CITY OF DULUTH

File Number	PL17-036	Contact	John Kelley, 218-730-5326	
Type	Variance, Rear Side Yard Setback	Planning Commission Date		April 11, 2017
Deadline for Action	Application Date	March 6, 2017	60 Days	May 5, 2017
	Date Extension Letter Mailed	March 20, 2017	120 Days	July 4, 2017
Location of Subject		3421 East 1 st Street		
Applicant	James Mohn and Heather Muster	Contact	3421 East 1 st Street	
Agent	CF Designs (Jeremy Jones)	Contact	230 East Superior Street	
Legal Description		010-1370-00800		
Site Visit Date		March 31, 2017	Sign Notice Date	
			March 28, 2017	
Neighbor Letter Date		March 27, 2017	Number of Letters Sent	
			32

Proposal

A variance to construct a screen porch addition and deck to the rear yard of the house that will encroach 10.5 feet into the rear yard setback.

1 SITE PLAN
SCALE: 1/16" = 1'-0"

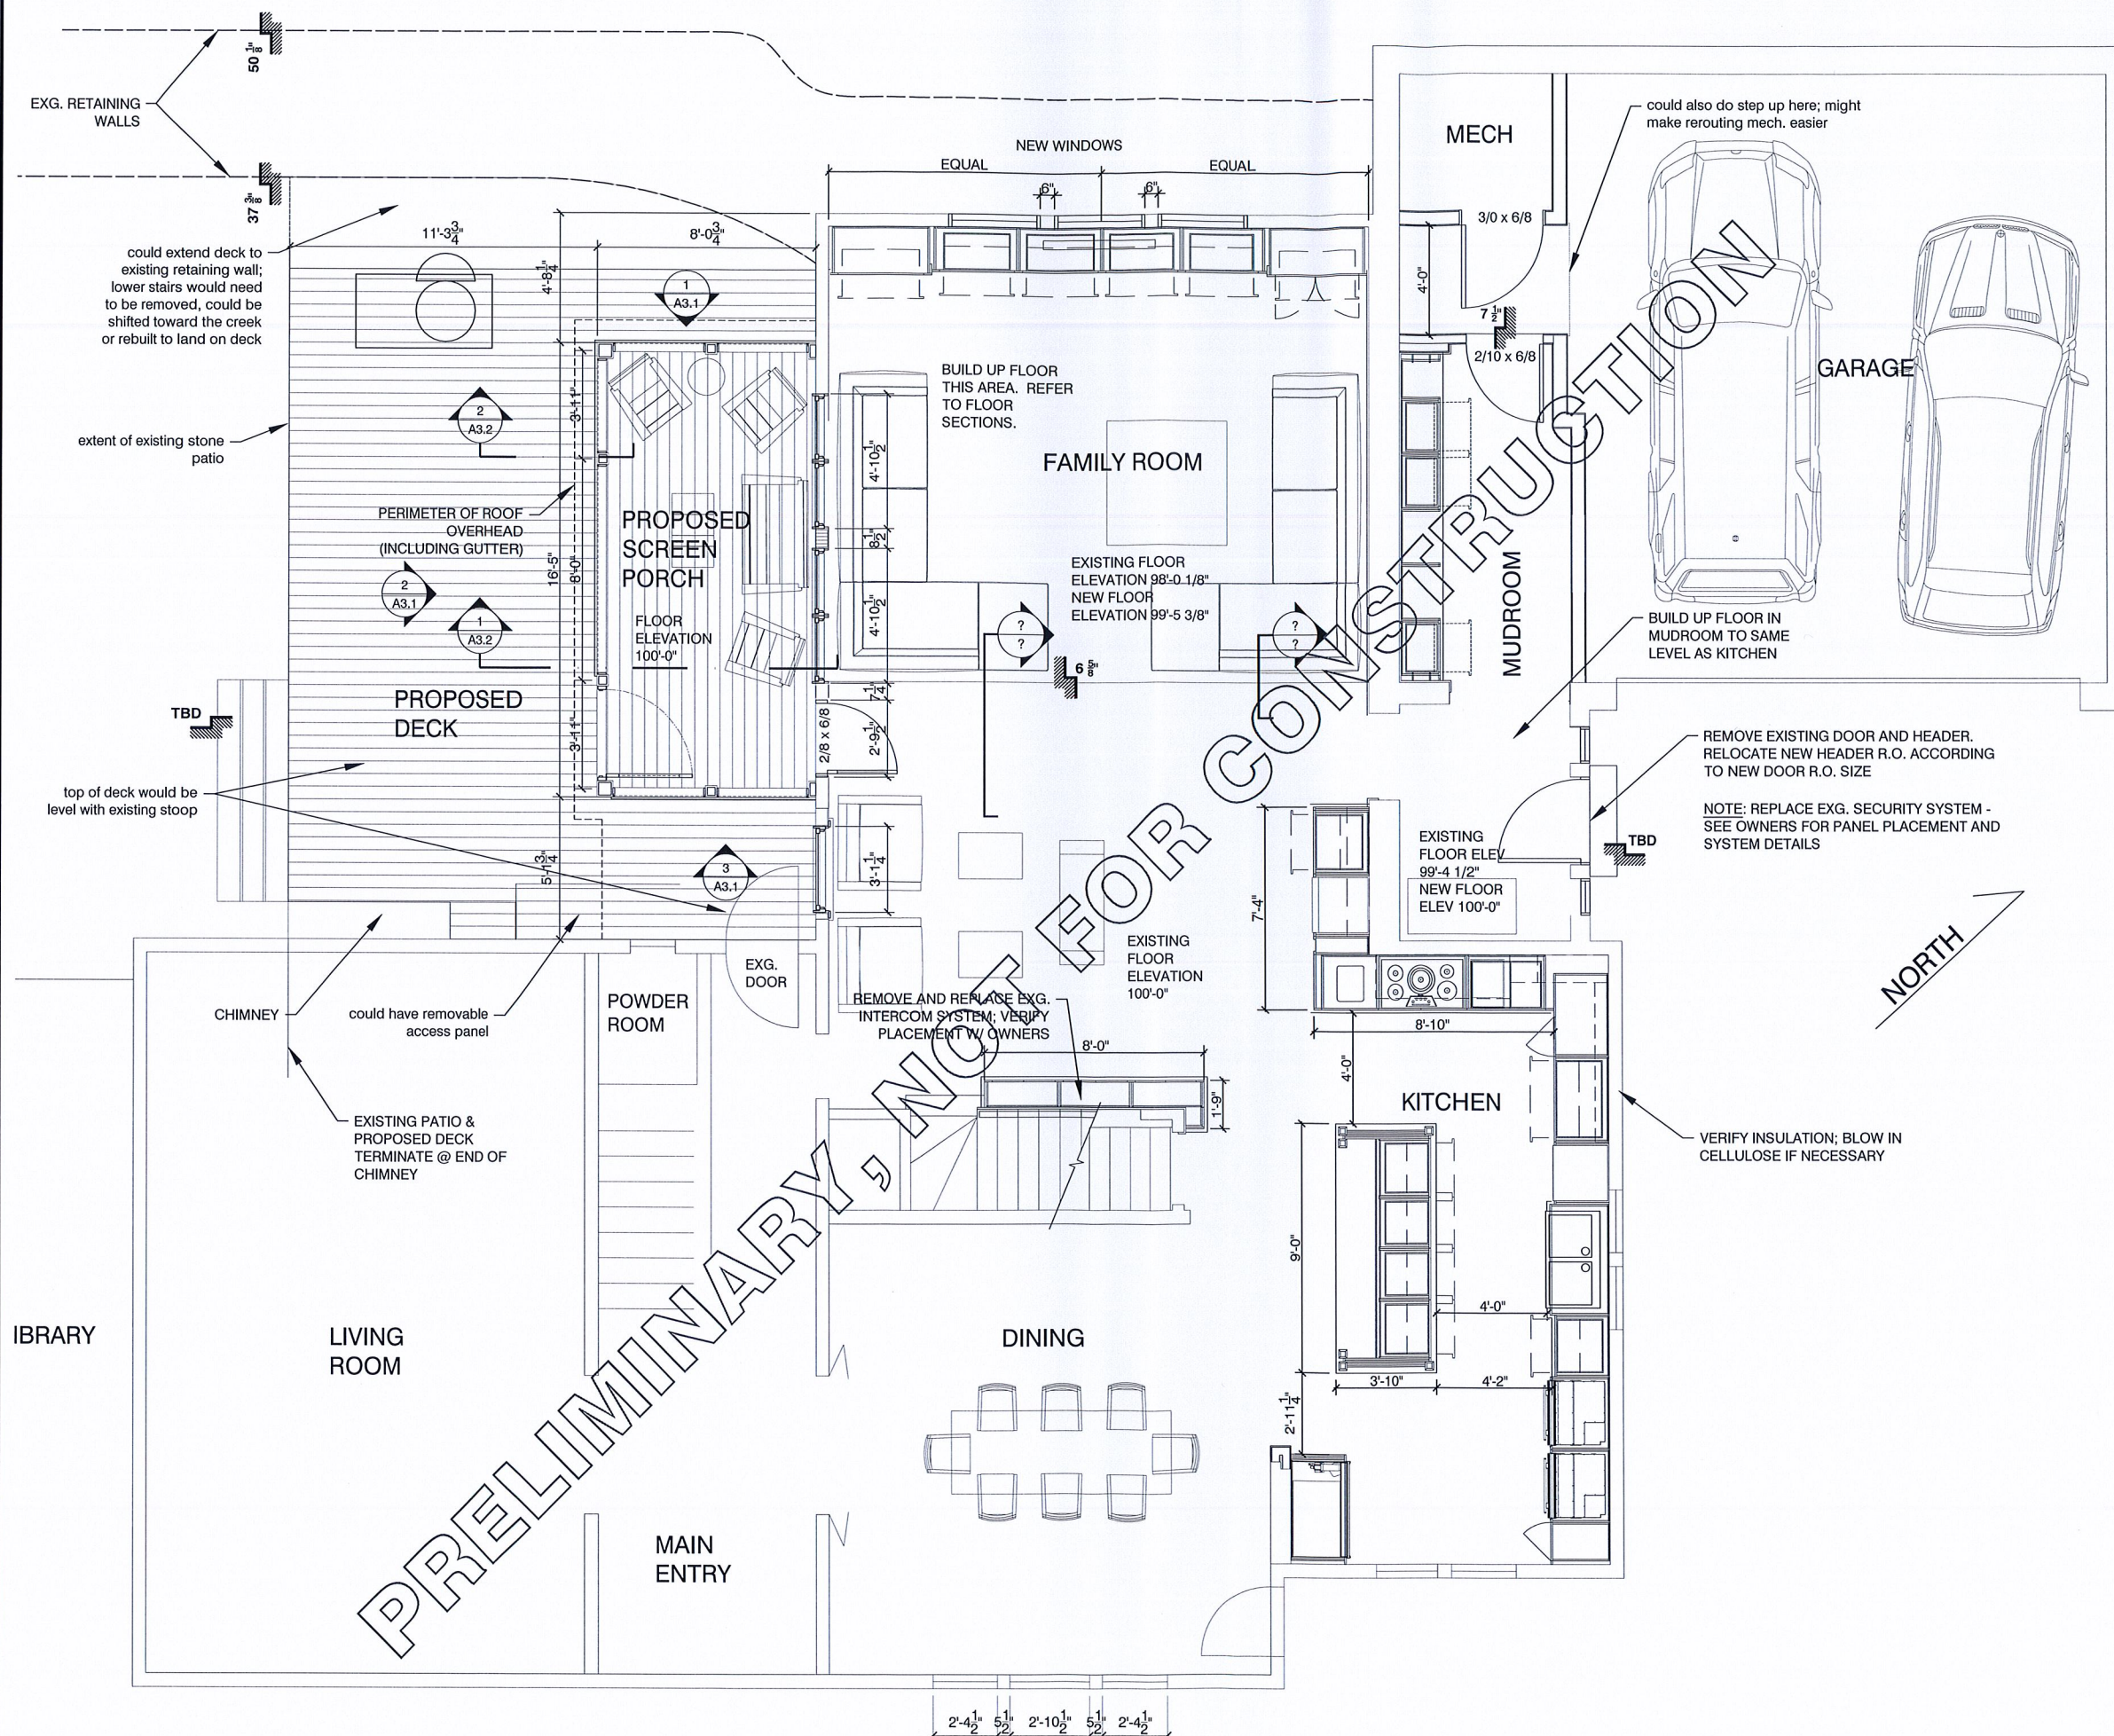
- 5) Staff finds there are alternatives for constructing the screen porch and deck that wouldn't require a setback variance. The proposed screen porch and deck could be reconfigured and constructed to fit within the area west of the patio doors. This area would allow for a reasonably sized screen porch and deck to achieve the objectives of the applicant. Therefore, staff finds that there aren't practical difficulties or hardship involved in adhering to the normal setbacks for the property. The need for the variance is caused by the applicant's desire to add on to the home in a particular manner and is not caused by the shape of the lot or its inherent topography.

Based on the above findings, staff finds that the standard for variance has not been met and, therefore, recommends the Planning Commission deny the requested variance because there aren't practical difficulties or hardship caused by adhering to the normal setbacks for the property. There is reasonable space to construct a screen porch and deck outside the setback and that the need for the variance is caused by the applicant's desire to add on to the home in a particular manner and is not caused by the shape of the lot or its inherent topography.

Staff also finds that, should the Planning Commission find reason to grant the variance, neither the essential character of the area nor the purpose and intent of the UDC or Comprehensive Plan will be compromised by the variance. Additionally, if the Planning Commission decides to grant the variance, staff recommends that the variance be limited to the project shown on Sheet S2.0 prepared by cf design ltd dated 12/9/2015.
